NUREG-1851

# Safety Evaluation Report for the American Centrifuge Plant in Piketon, Ohio

Docket No. 70-7004

USEC, Inc.

Figure 1-1 Simplified Base Curve Recommended for Calculation of CRR From the Standard Penetration Test Results (Modified from National Center for Earthquake Engineering Research, 1997)

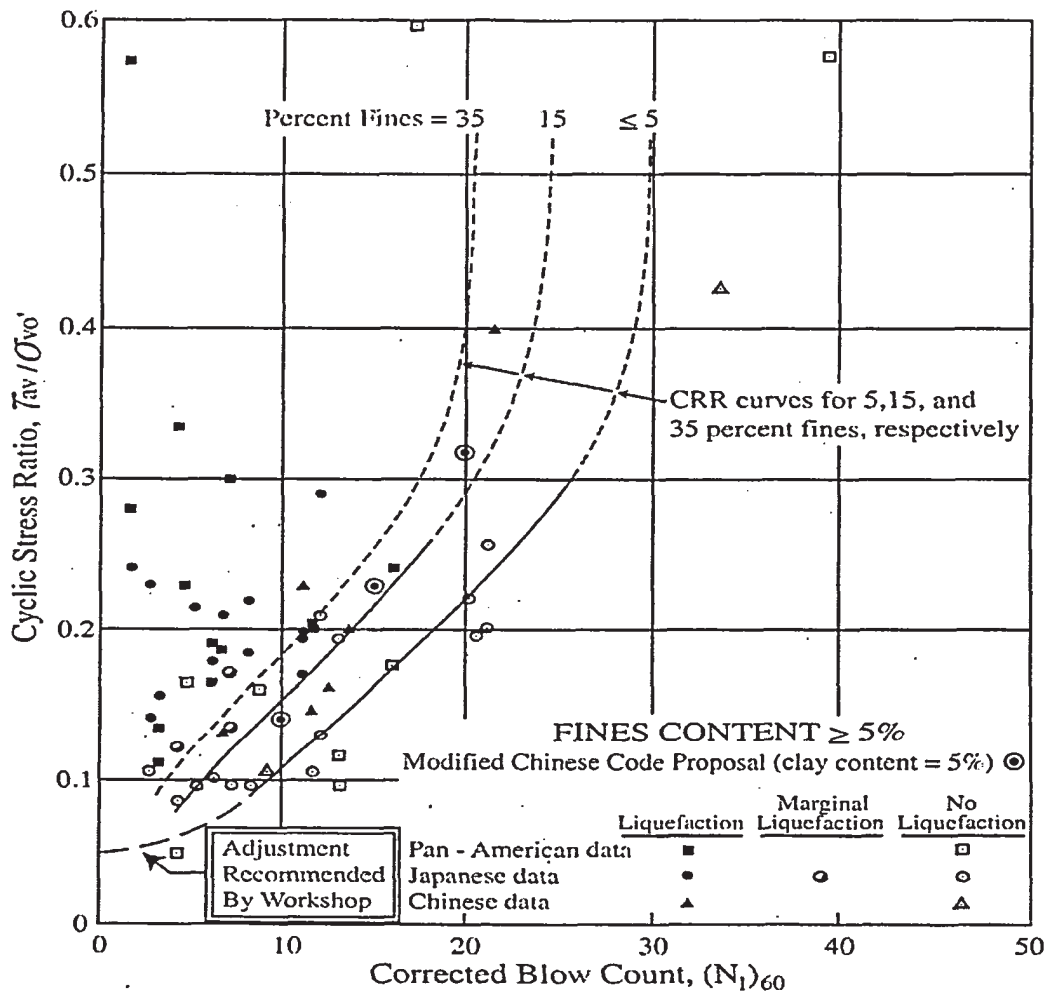
For earthquakes of different magnitudes, the CRR curves shown in Figure 1 must be scaled up or down on the diagram. The suggested magnitude scaling factors can be found in NCEER (NCEER, 1997). According to the LA (USEC, 2006c) and the ISA Summary (USEC, 2006b), the general DBE for the proposed ACP except the X-3346 building Customer Service Area has a Richter magnitude of 5.25 with a horizontal peak ground acceleration of 0.15g. The

magnitude scaling factor for this earthquake magnitude is at least 1.43. The magnitude scaling factor of 1.43 is suggested for an earthquake of magnitude 5.5 and may be considered as a bounding value compared with the values suggested by other researchers (Table 3, NCEER, 1997). Applying this scaling factor, the CRR curves in Figure 1-1 represent a safety factor of at least 1.43 for earthquakes of magnitude 5.25.

Figure 3-1a ISA for the ACP

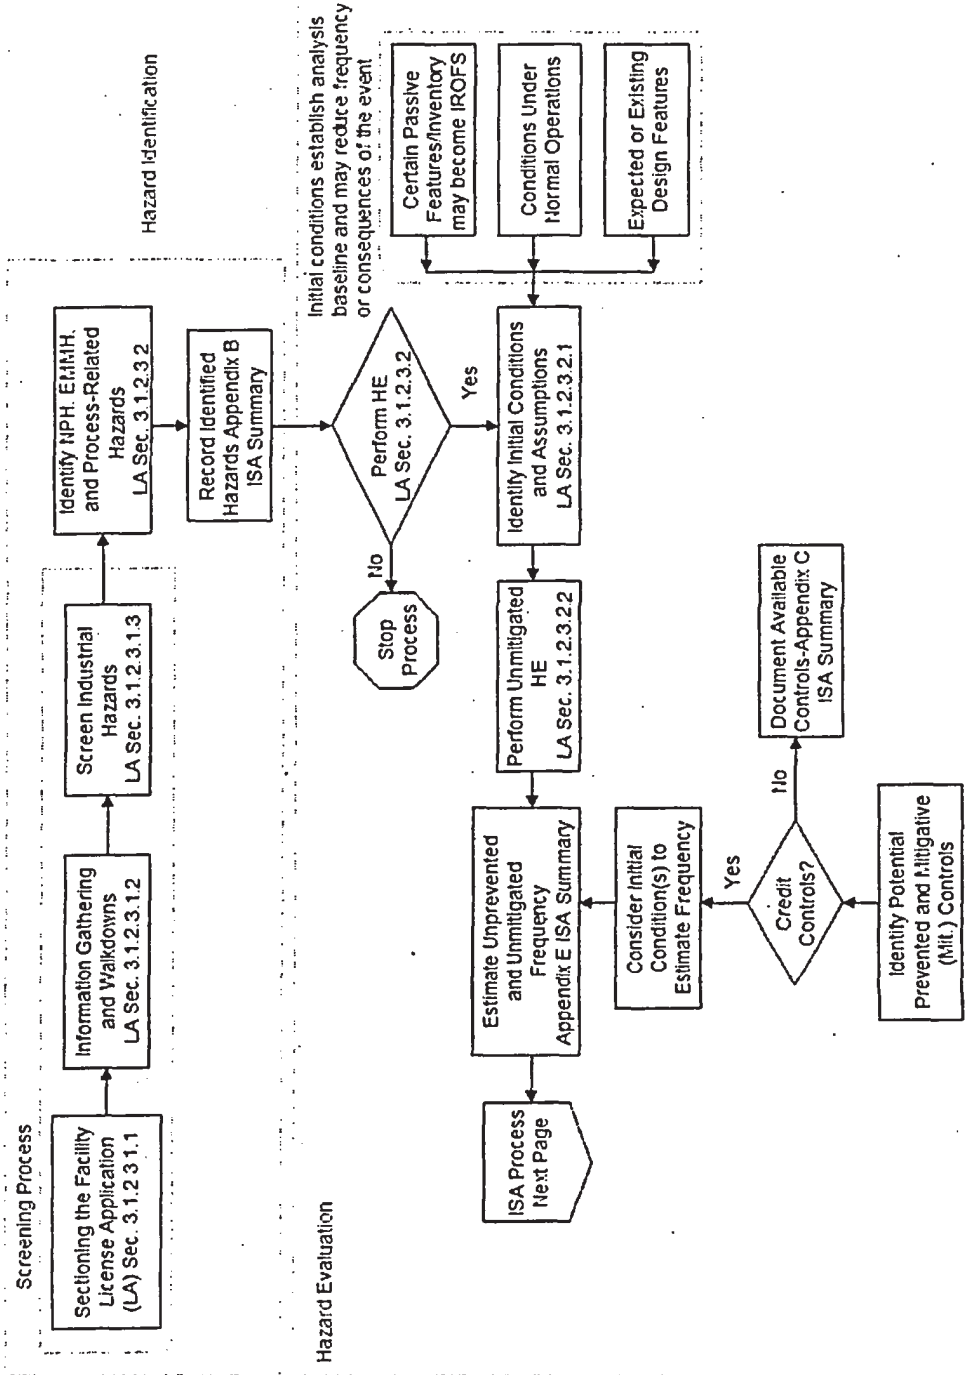
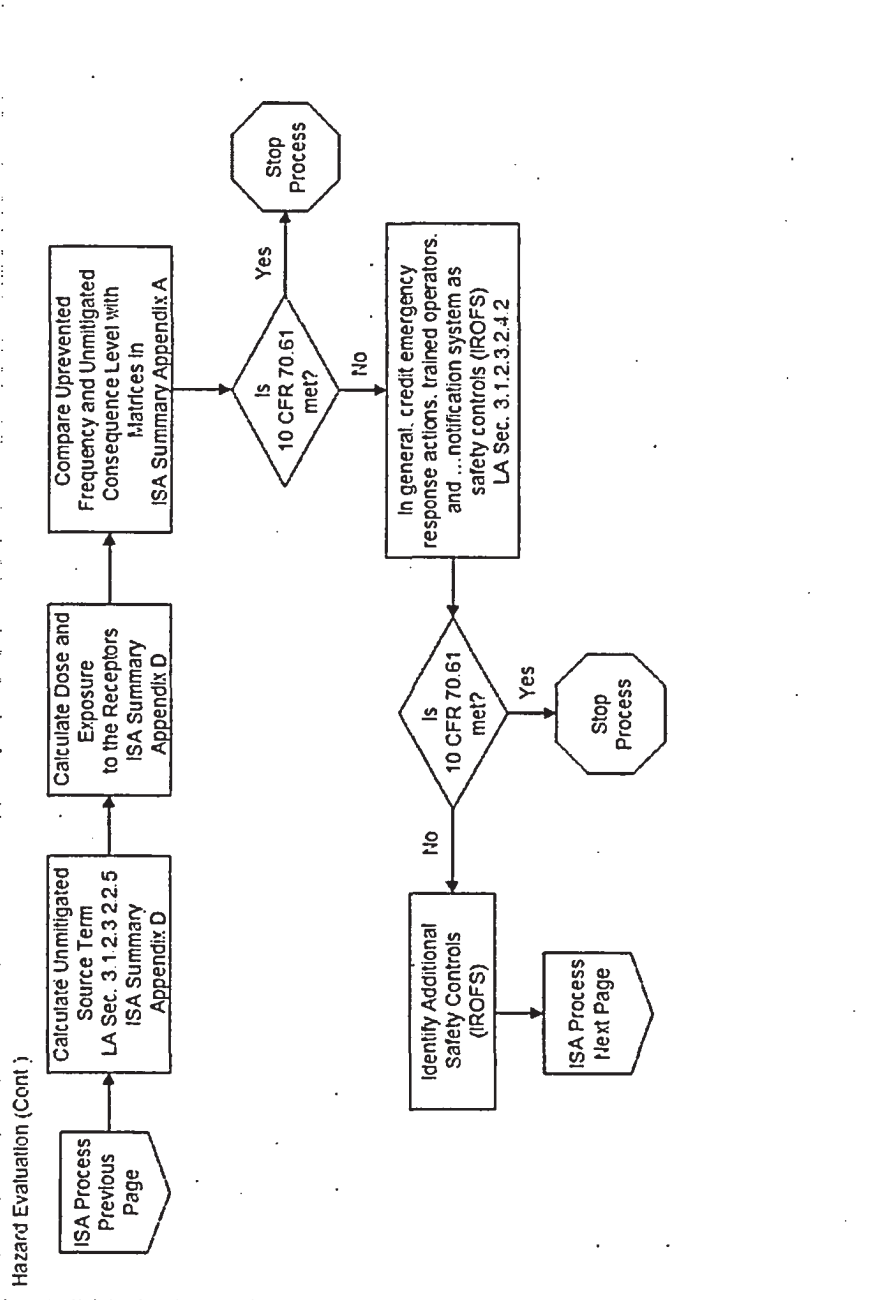
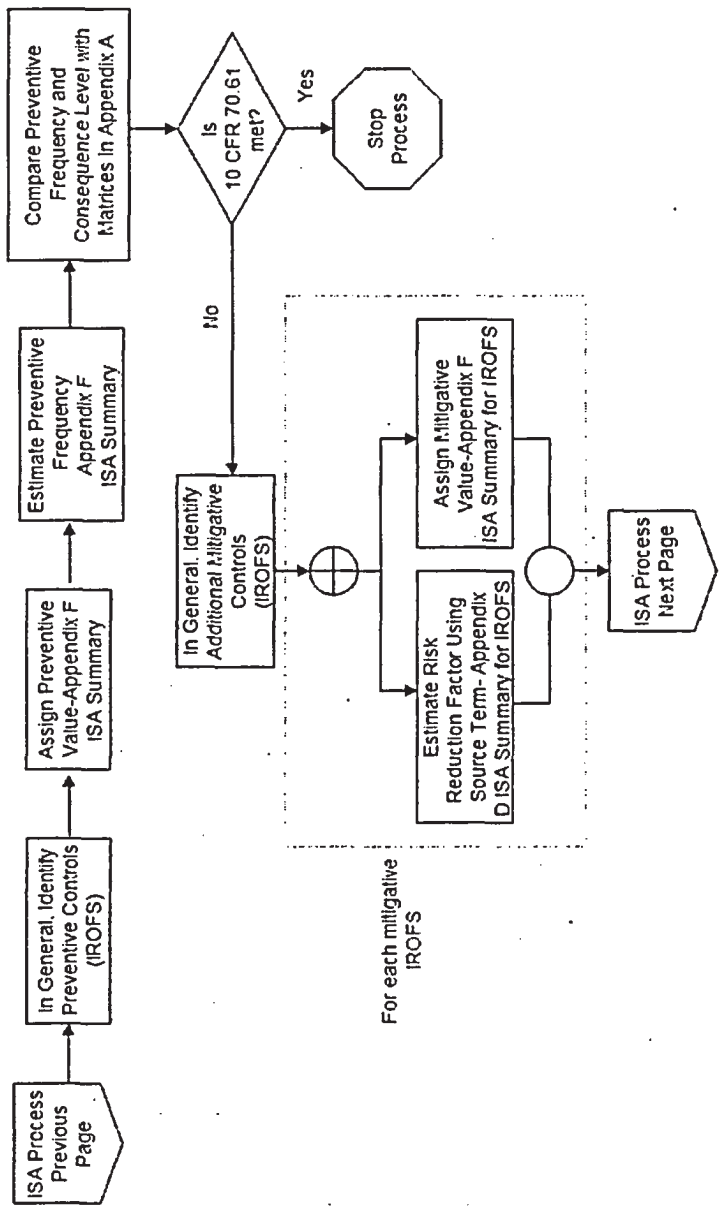
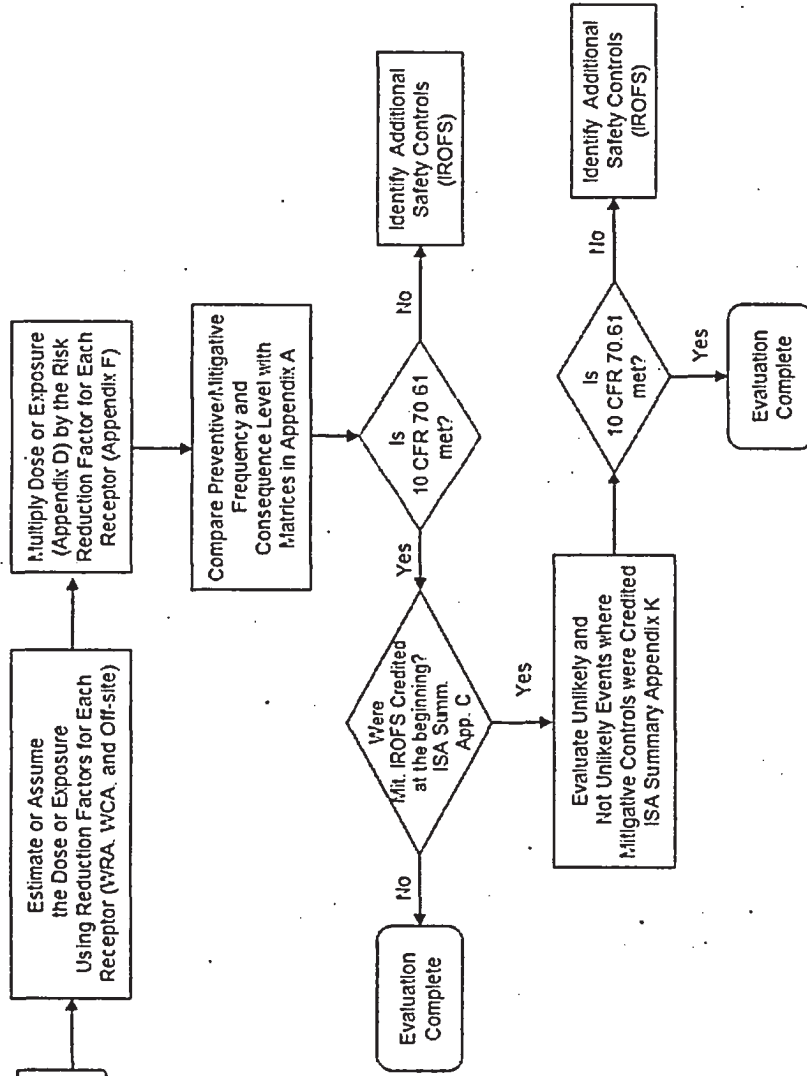
The hazard analysis for the ISA is developed using two primary activities: (i) hazard identification and (ii) hazard evaluation. These activities result in the estimates of consequences and frequencies such that scenarios can be identified that have a potential risk to the public, workers, and the environment that exceeds the 10 CFR 70.61 performance requirements. The hazard identification process is shown in the top boxed-in set of ISA process steps in Figure 3-1a. The hazard evaluation process is comprised of the rest of the process steps shown in Figures 3-1a - 3-1d.

If the 10 CFR 70.61 performance criteria are not satisfied, the process progresses as shown at the start of the process as shown in Figure 3-1c where available preventive controls are credited to meet the performance requirements. These controls are selected in an order of preference. If available, engineered or designed controls will be selected before administrative controls, to use the inherent reliability advantage of designed systems or components over that of required human action compliance. Defense-in-depth concepts using non-credited controls were also incorporated into the control strategy for a postulated event whenever possible according to Section 3.1.2.3.2.4 of the LA (USEC, 2006b). These defense-in-depth controls are generally controls that were listed as available when the sequences were formulated but not explicitly required to meet the performance requirements.

The final steps in the ISA analysis are shown in Figure 3-1d. This step of the analysis evaluates the likelihood of failure of mitigative IROFS for events that are not prevented or made to be "highly unlikely." Events for which mitigative controls were credited were evaluated to examine the residual risk associated with the postulated failure upon demand of each mitigative IROFS. The approach used in the evaluation developed a series of sub-events designed to demonstrate that the risk of the event after failure of one or more mitigative controls is still within the 10 CFR 70.61 performance requirements. This evaluation is described and tabulated in Appendix K of the ISA Summary (USEC, 2006a).
